**Overview:** Production error in version 1.0 harnesses; The immobilizer wire (orange/black) is in pin position #4 instead of pin position #5. Although an effort to correct the issue was made, some quantity of harnesses did get shipped before the issue was spotted. We are advising to inspect the harness BLADE connector before attempting to install harness or program the module. This issue is not known to affect the version 2 harnesses, which require no modification.

**Overview:** Early versions of the FTI-STP1 harness require modification for **automatic transmission (AT)** applications, some of the product was able to be modified before release, but a small quantity was released without modification.

# FTI-STP1: Vehicle Coverage and Preparation Notes

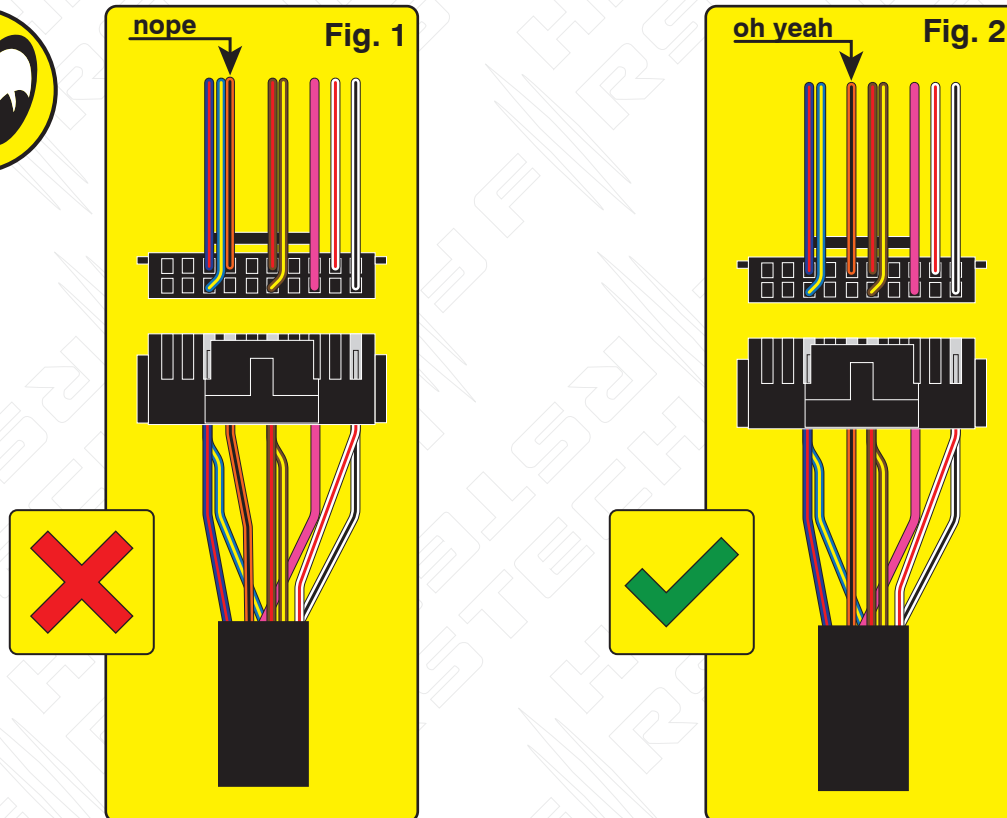
**Issue:** Module fails to program correctly to vehicle, does not allow the vehicle to be remote started.

**Correction:** Step 1.) Locate the orange/black wire and confirm whether it is positioned as illustrated in Fig. 1 or Fig. 2. If the wire is as illustrated in Fig.1, proceed with Step 2 through 5 and complete the repair procedure outlined, if the wire is as illustrated in Fig. 2, correction is not necessary, proceed with harness installation and module programming.

**Step 2.)** Using a pick, lightly depress the catch that secures the terminal in the housing then remove the wire and terminal from the housing.

**Step 3.)** Using a fine tip razor or utility knife, insert the blade beneath the terminal catch and raise it slightly, so that it can be reused to secure the terminal when reinserted into the BLADE connector housing.

**Step 4.)** Refer to Fig. 2 for correct position of the orange/black wire (next to brown/red) then reinsert the terminal, pressing lightly until the catch 'snaps' into place, securing the terminal in the connector housing.

**MODIFICATION REQUIRED FOR A/T APPLICATIONS, ONLY WITH v 1.0 HARNESS**

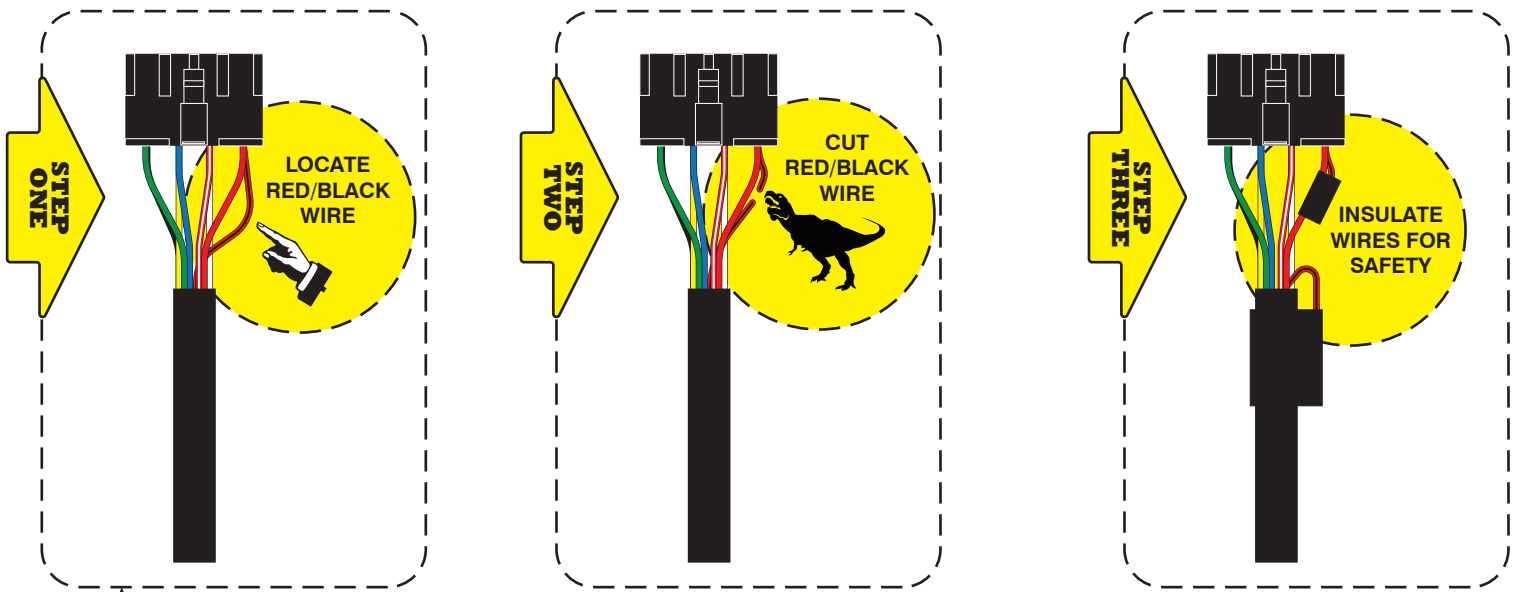
**Issue:** The FTI-STP1 T-harness has been designed to be compatible with A/T (automatic transmission) & M/T (manual transmission) applications, but due to an oversight in early production runs, the selection was defaulted to M/T mode.

Using a harness configured for an M/T application, in an A/T equipped vehicle, could result in vehicle module damage, it is advised that the harness be returned to A/T mode before installation in vehicles equipped with an automatic transmission.

**Correction:** Locate the **red/black (+ Clutch)** wire provided in the CN1 connector of the main harness assembly. Cut the **red/black** wire, either flush to the CN1 connector, or leaving enough wire exposed so that you can insulate and secure the ends of the wire that remain after cutting. Insulate each of the remaining ends of the **red/black** wire and secure to prevent any possibility of a short circuit. **If the red/black wire has already been disconnected, no further modification is required for A/T applications**

**MODIFICATION NOT REQUIRED WHEN USING FTI-STP1 (v 1.0) HARNESS IN M/T APPLICATIONS, OR WHEN USING THE FTI-STP1 (v 2.0) HARNESS**

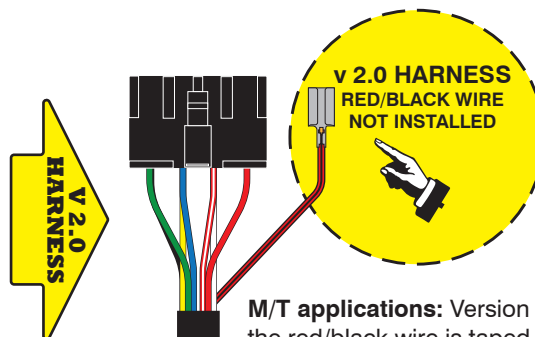
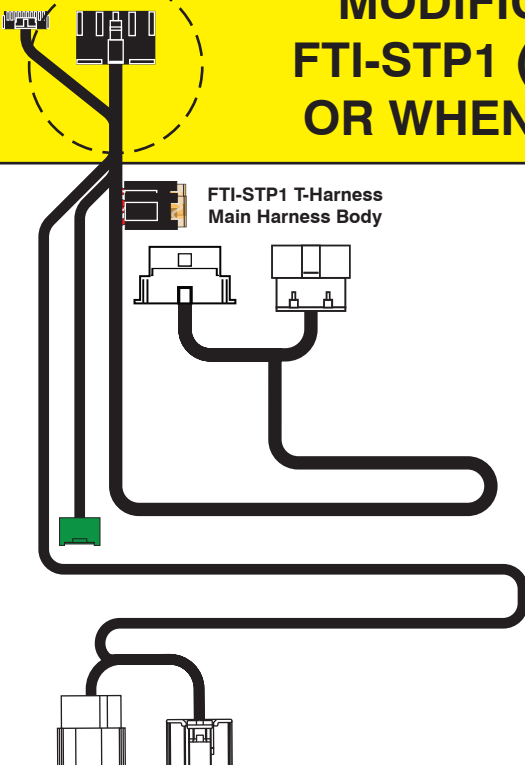
**M/T applications:** Version 2.0 harness, the red/black wire is taped to the main harness when shipped, and must be installed in the CN1 connector when installed.

**A/T applications:** Leave the red/black wire taped to the harness, it is not required for A/T applications
